WST8 – Reworking Rear Lid (Workshop Campaign)

Vehicle Type: **911 GT3 (992)**

Concerns: **Screws on rear lid**

Cover (rear window)

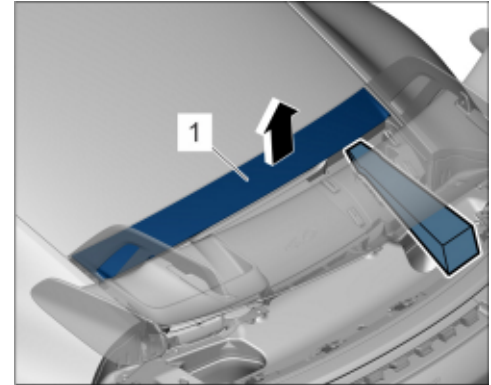
Work Procedure: 1 Carefully unclip trim (rear window) ⇒ *Cover (rear window) -1-* using a plastic wedge ⇒ *Cover (rear window) -Arrow-*.

Rear lid

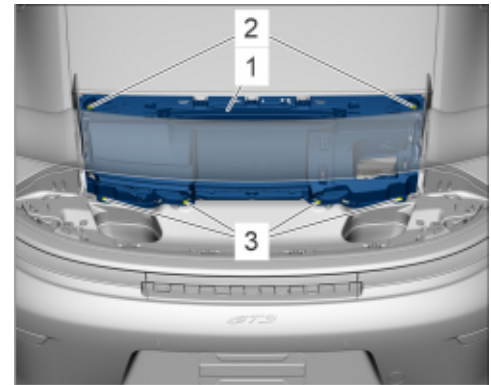
Cause: **There is a possibility that the fastening nuts on the rear lid on the affected vehicles have not been tightened to the specified tightening torque.**

If this is the case, this can cause noises with the rear lid while driving.

2 Tighten fastening nuts ⇒ *Rear lid -2-* securing rear lid ⇒ *Rear lid -1-* to the specified tightening torque.
Tightening torque 8 Nm(5.9 ft lb)
